N62661.AR.003456  
NS NEWPORT  
5090.3a

LETTER AND ATTACHED U S NAVY RESPONSE TO U S EPA REGION I AND RHODE  
ISLAND DEPARTMENT OF ENVIRONMENTAL MANAGEMENT COMMENTS ON THE DRAFT  
SAMPLING AND ANALYSIS PLAN FOR SOIL PRE-DESIGN INVESTIGATION DECISION  
UNITS 1-1, 1-2, AND 1-3 AT TANK FARM 1 (SITE 7) OPERABLE UNIT 13 (OU 13) NS  
NEWPORT RI  
10/29/2015  
RESOLUTION CONSULTANTS

RE: Response to Comments on Draft Sampling and Analysis Plan  
Soil Pre-Design Investigation (PDI)  
Decision Units 1-1, 1-2, and 1-3 at Tank Farm 1 (Site 7), OU 13  
Naval Station (NAVSTA) Newport, Portsmouth, Rhode Island

Navy Responses to Regulatory Agency Comments  
EPA Comments, September 10, 2015  
RIDEM Comments, September 29, 2015

**FIGURE 5**  
**CONCEPTUAL PDI SAMPLE LOCATIONS**  
**FOR DECISION UNIT 1-3**  
**TRANSFORMER VAULT 3**

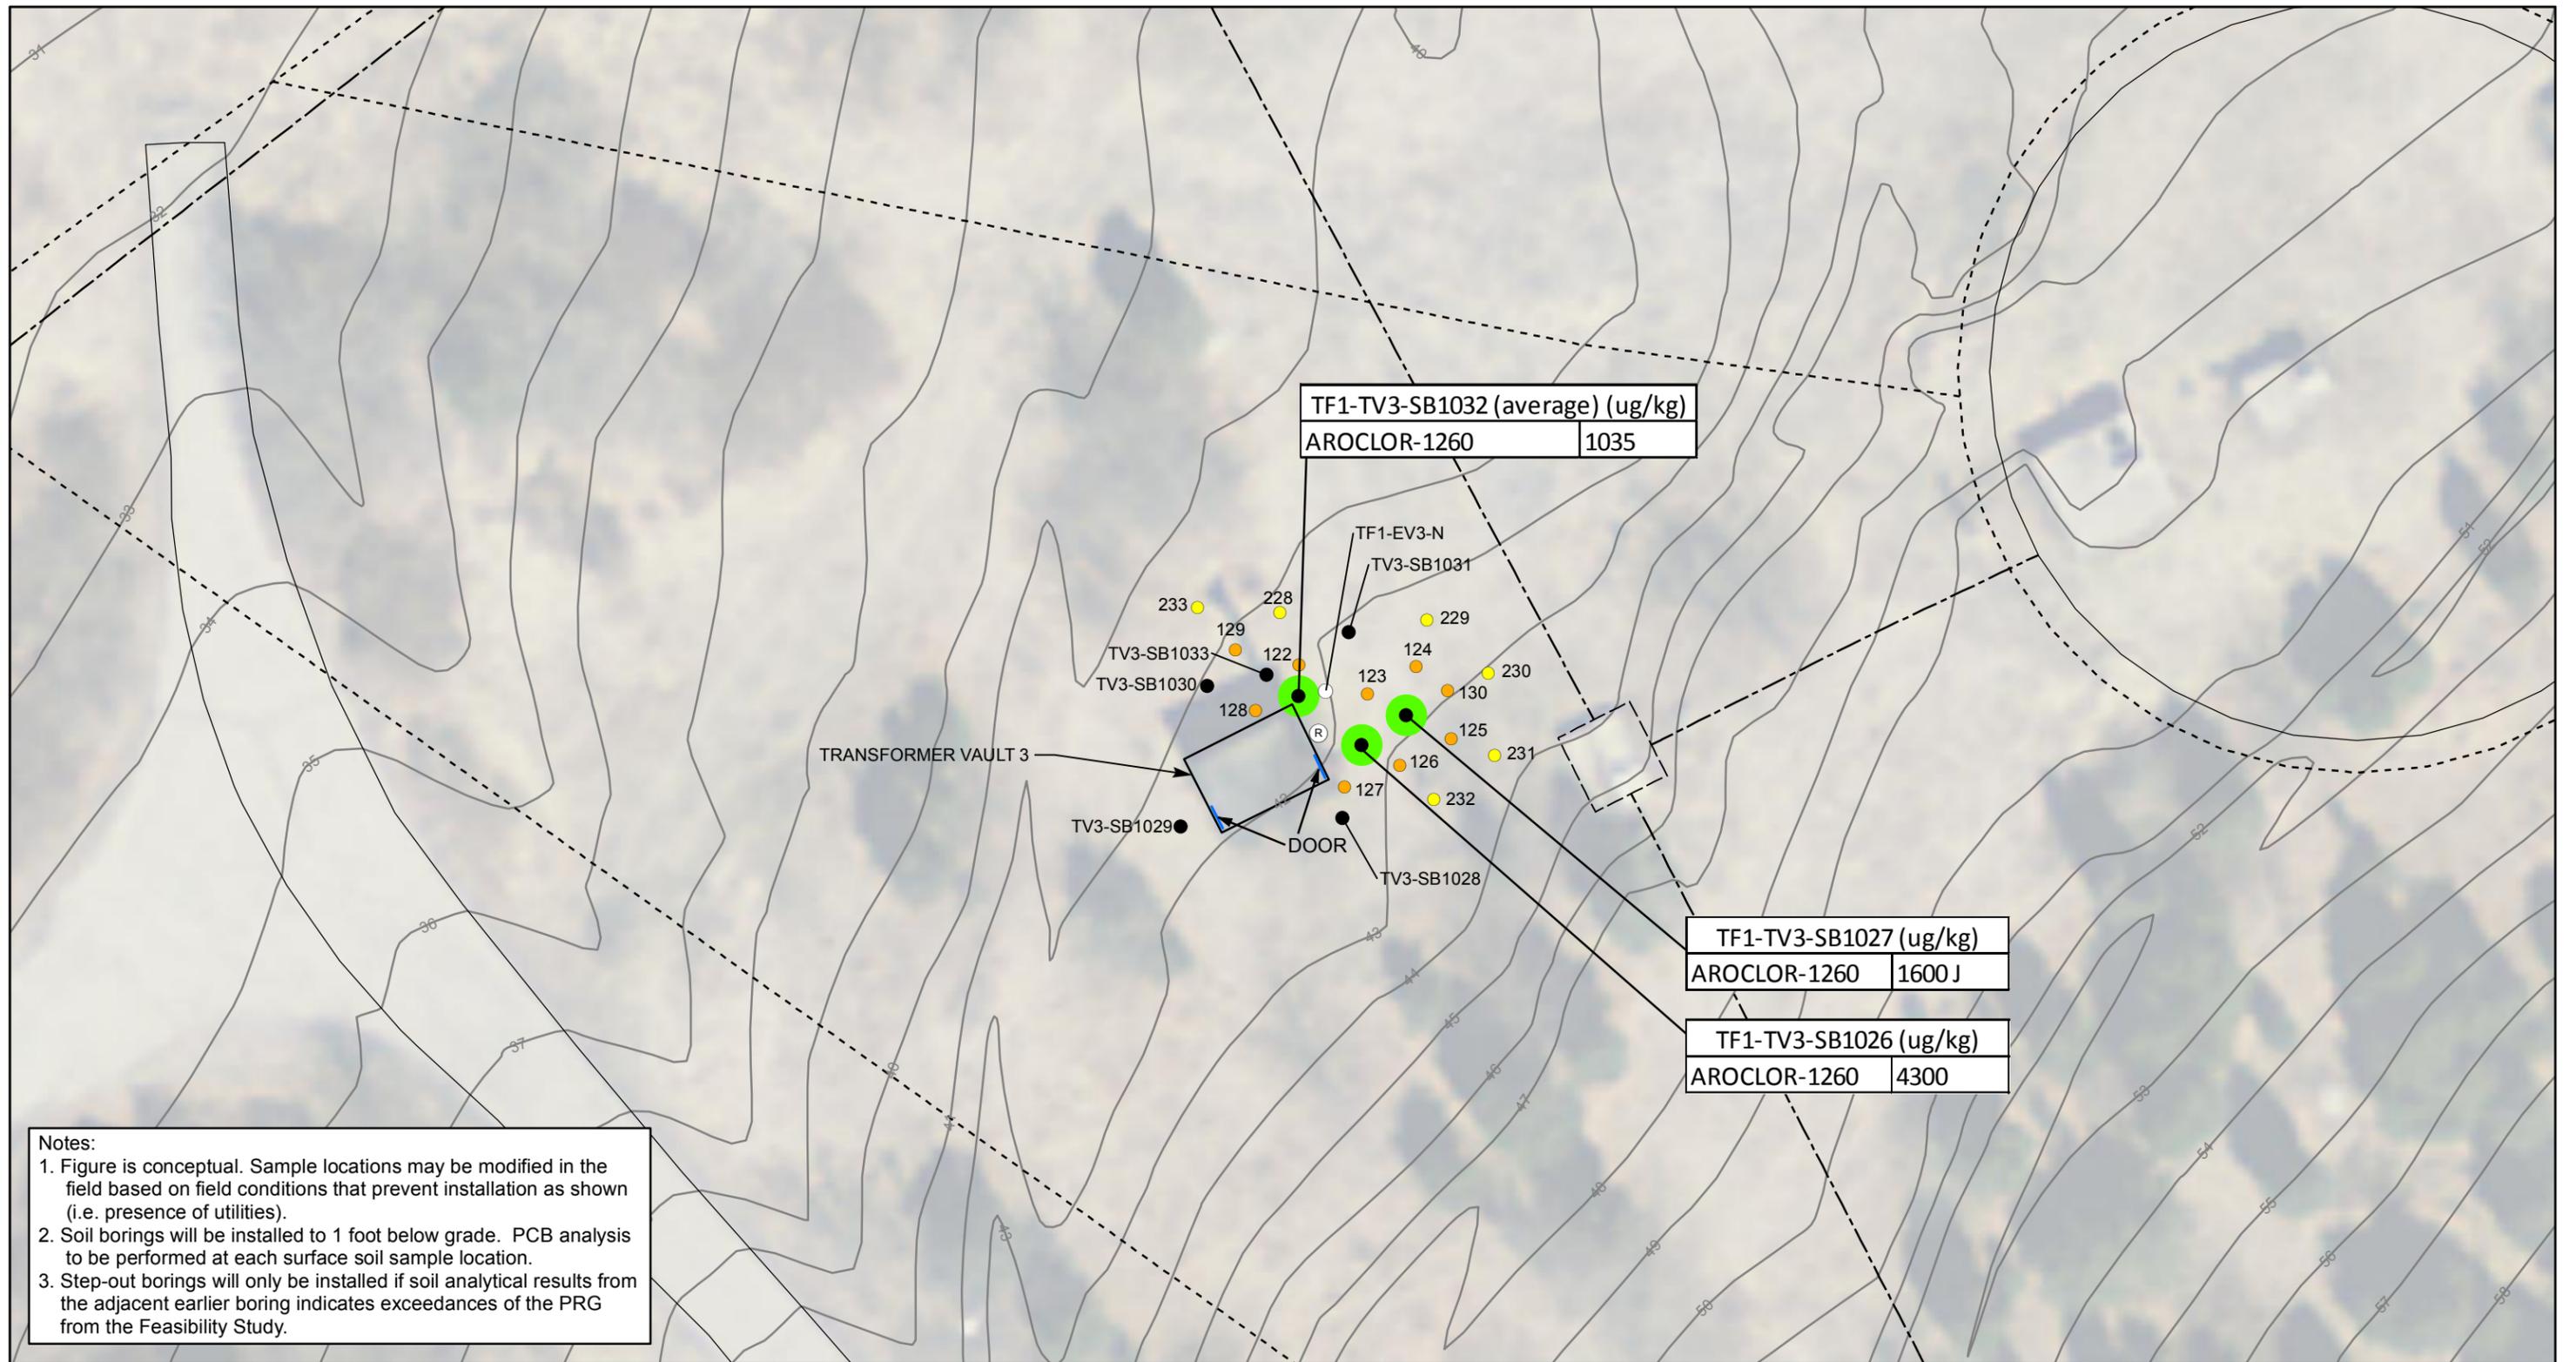
*EPA Specific Comment 12: Figure 4 – All the sample locations shown in this figure appear to be located farther southeast than shown in the Data Gaps Assessment Report. For example, sample SB1026 was collected directly outside the door and SB1027 was stepped out in alignment with the door. Sample SB1032 was collected near the corner of the building just down gradient of the rectifier (at or very near the proposed location shown for PDI sample 122). Sample SB1033 was collected down gradient of SB1032 as a step-out location (not around the corner from the rectifier). Please refer to Appendix A of the Data Gaps Assessment Report for field documentation of sample locations. Navy should obtain GPS coordinates from Tetra Tech for SB1032 and SB1033 and review and verify all sample locations shown on this figure. It will be necessary to capture the location of the four corners of the building to ensure that sample locations are located correctly relative to the building. PDI sample locations should be adjusted as necessary. It is expected that the limits of soil excavation will extend to clean samples, so place PDI samples accordingly.*

*EPA Specific Comment 13: Figure 4 – EPA requests that the PDI sampling encompass sample SB1033 because the presence of Aroclor 1254 at this location and not at SB1032 suggests the probability of a separate release/discharge. PDI sampling should determine the extent of Aroclor 1254 in a down gradient location. Should down gradient sampling produce acceptable results, sample location SB1033 may be determined to be suitable for establishing the limit of excavation. (Note that Figure 4-6 of the DGA Report has transposed the results for SB1033 and SB1032.)*

*EPA Specific Comment 14: Figure 4 – As placed, the initial refinement samples leave a data gap east-northeast of SB1027; therefore, the extent of excavation is not limited in that direction until step-out sample 230. Add another initial refinement sample in that direction to better constrict the limit of excavation.*

*RIDEM Specific Comment 1. Figure 4 - Conceptual PDI Sampling Locations for Decision Unit 1-3. Please: 1) note typographical error of "PRG Exccedance"; 2) remove "-D" from the sample ID TF1-TV3-SB1027. In addition, RIDEM notes that sample SB1032-D presents the maximum concentration between the primary and field duplicate samples, rather than an average concentration. Although this approach is conservative and preferred by RIDEM, it is inconsistent with the approach taken with respect to other contaminants (i.e., PAHs at SB1011 as shown on Figure 3, which considers the average concentration when comparing to PRGs). Please be consistent when using data from duplicate samples.*

Response: Upon review of Figure 4, it was discovered that the building (transformer vault) outline was incorrectly located, which resulted in the boring locations appearing incorrect relative to the building. The boring locations were reviewed and are fact accurate based on the coordinates. The actual vault location has been modified on Figure 5 (formerly Figure 4) and verified using coordinates from a survey of the vault corners, which was obtained from Tetra Tech. Due to the shift in the vault location, potential step-out boring 233 was eliminated, but a new initial refinement boring was added to the west of SB1032. See the attached revised figure (now called Figure 5), which provides the corrected vault outline and reflects adjustments to the proposed sampling locations. The text in Worksheet #10 will be modified to state that the coordinates for the historical soil borings were obtained from the Navy's electronic database (NIRIS). The table of GPS coordinates was checked and is accurate. The updated Tables 4 and 5 (previously 3 and 4) are also attached.

Response: An initial refinement boring and step-out boring will be added downgradient of SB1033. See the attached revised figure (now called Figure 5) which shows these proposed locations. The updated Tables 4 and 5 (previously 3 and 4) are also attached. These borings will also be added to the Sample Details Table (SAP Worksheet #18, 19, 20, and 30).

Response: One initial refinement boring will be added. Boring 230 will serve as the step-out sample. See the attached revised figure (now called Figure 5) which shows this proposed location. The updated Tables 4 and 5 (previously 3 and 4) are also attached. This boring will also be added to the Sample Details Table (SAP Worksheet #18, 19, 20, and 30).

Response: See attached revised figure (now called Figure 5) which addresses these corrections. Note that the PCB concentration at SB1032 has been replaced with the average concentration between the original sample and field duplicate. This has no impact on the proposed sampling.
